ADDENDUM NO. 1

**ARCADIA HIGH SCHOOL
LOCKER ROOM ALTERATION
ARCADIA UNIFIED SCHOOL DISTRICT**

tBP/ARCHITECTURE
4611 Teller Avenue
Newport Beach, CA 92660
949-673-0300

This Addendum forms a part of the Contract Documents and modifies the original Bidding Drawings dated August 15, 2024, and Specifications dated July 2024. Acknowledge receipt of this Addendum in space provided on the Bid Form. Failure to acknowledge may subject Bidder to disqualification.

A2-1

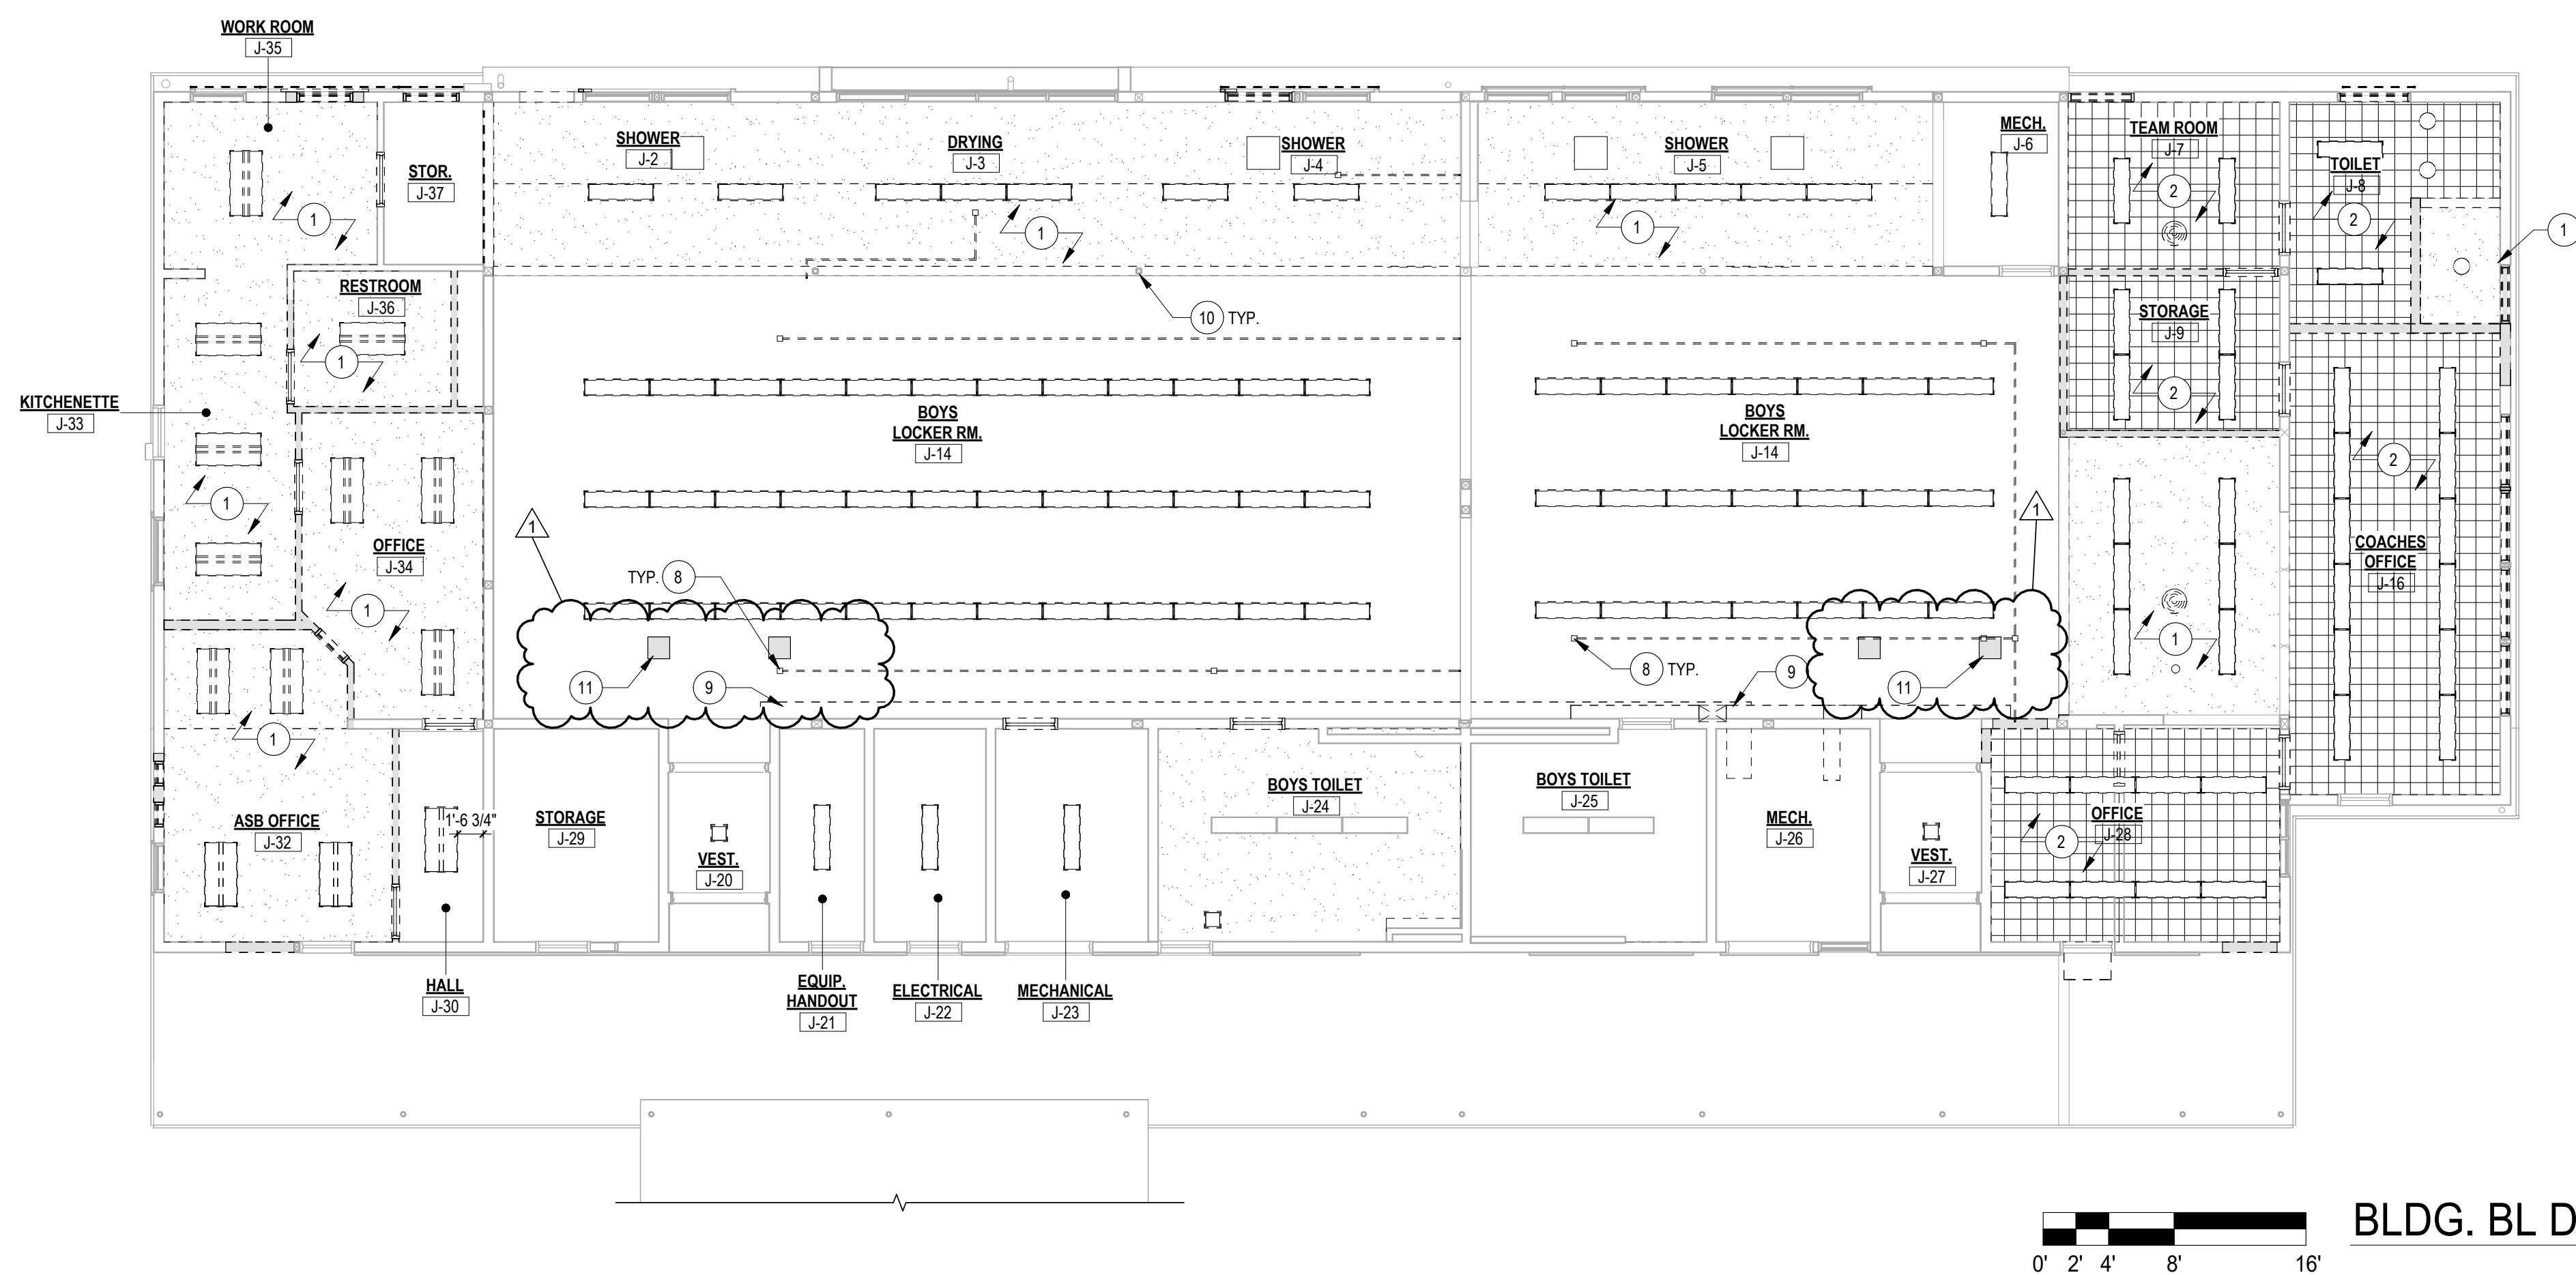
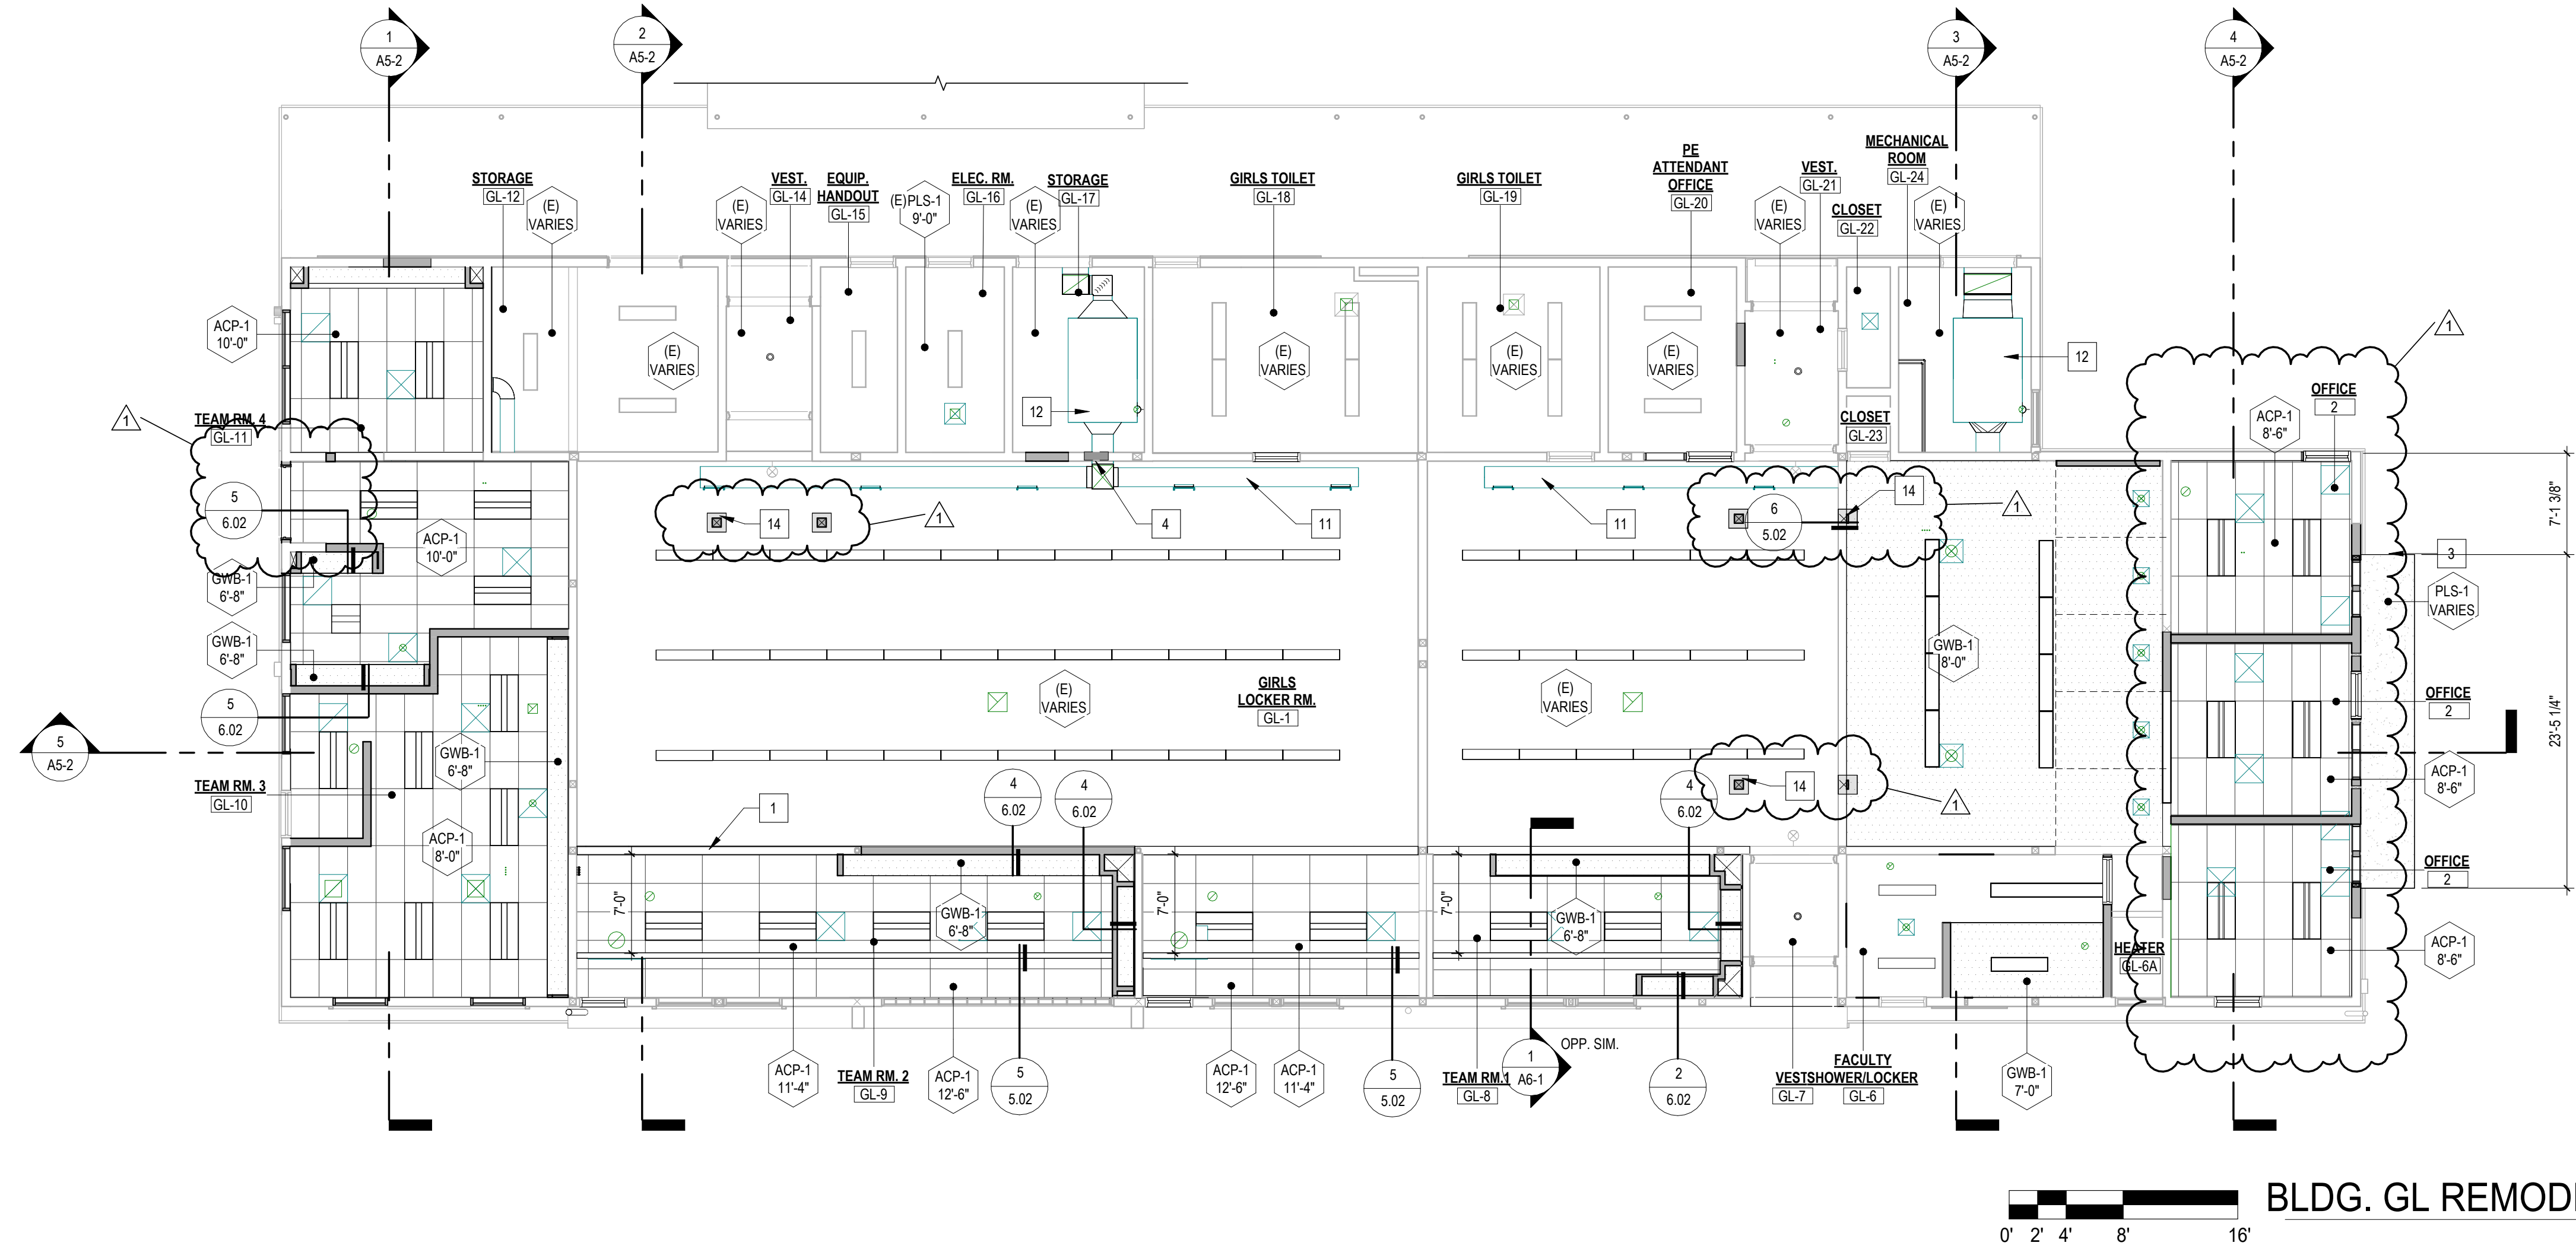
6. SHEET A2-1 – BUILDING BL – REFLECTED CEILING PLAN
Replace full size sheet drawing **A2-1** in its entirety, issued with this addendum.
Changes include:

- a. Revise ceiling layout in accordance with floor plan update.
7. SHEET A2-2 – BUILDING GL – REFLECTED CEILING PLAN
Replace full size sheet drawing **A2-2** in its entirety, issued with this addendum.
Changes include:

drawing title:
BLDG. GL - REFLECTED
CEILING PLAN

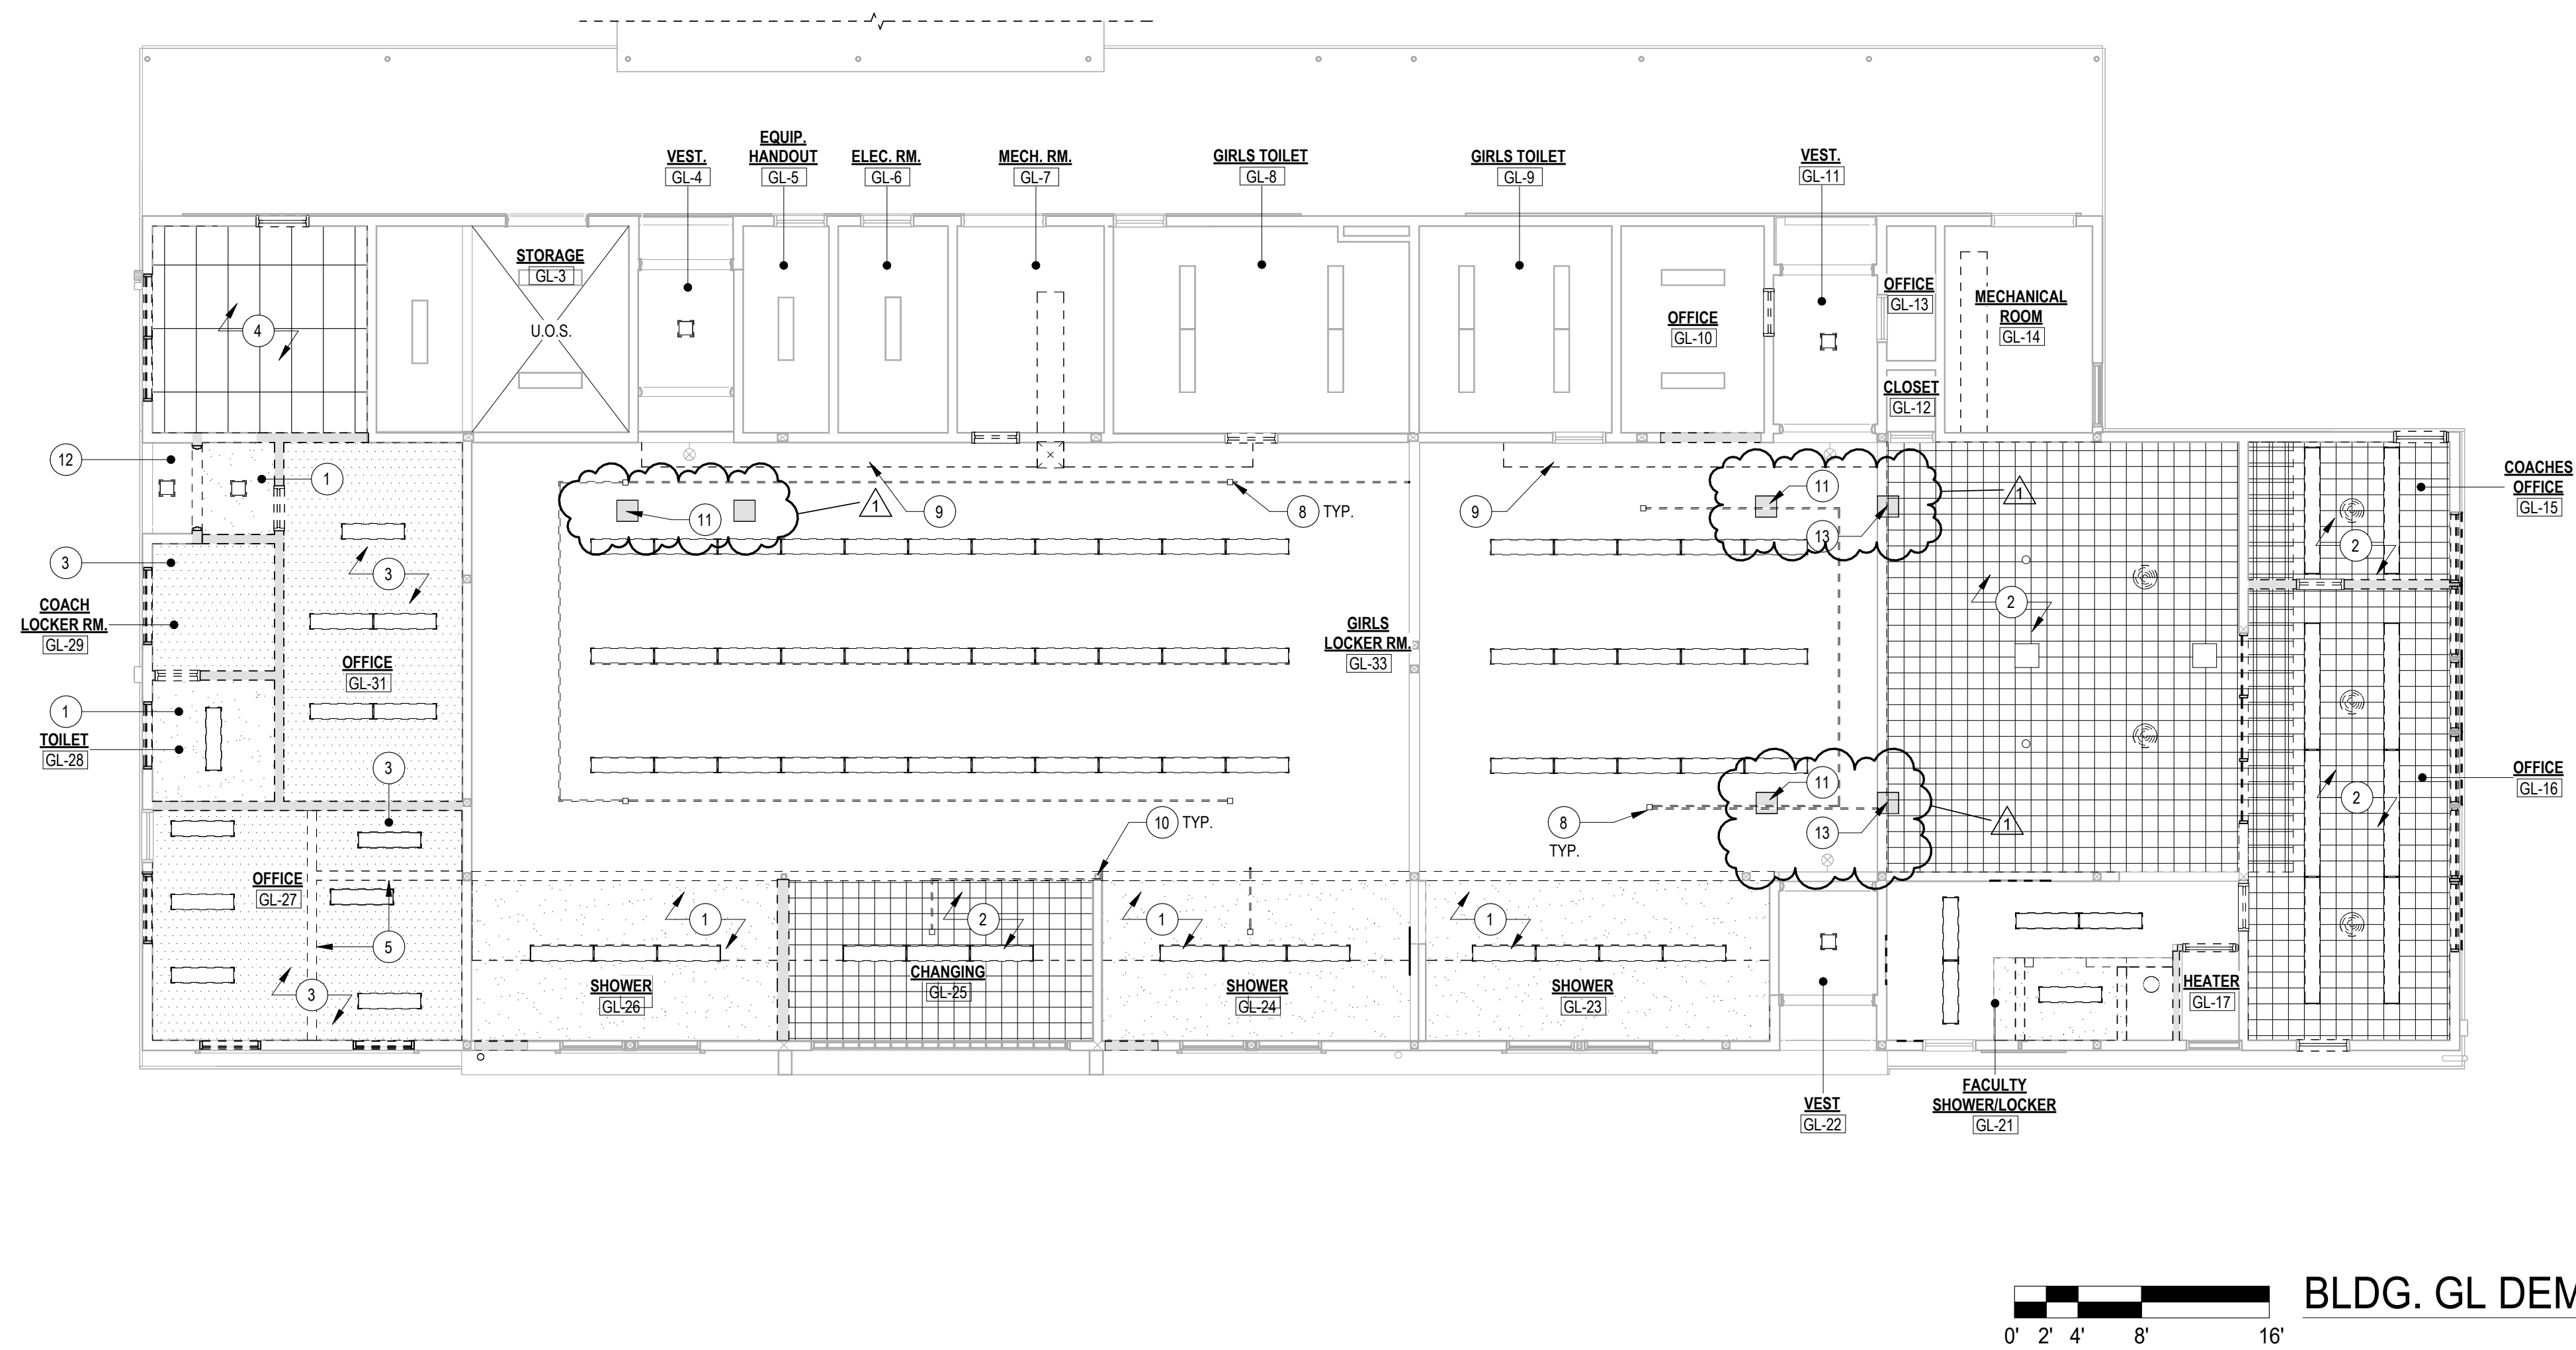
- a. Revise ceiling layout in accordance with floor plan update.
8. SHEET A3-1 – BUILDING BL – ROOF PLANS
Replace full size sheet drawing **A1-2** in its entirety, issued with this addendum.
Changes include:
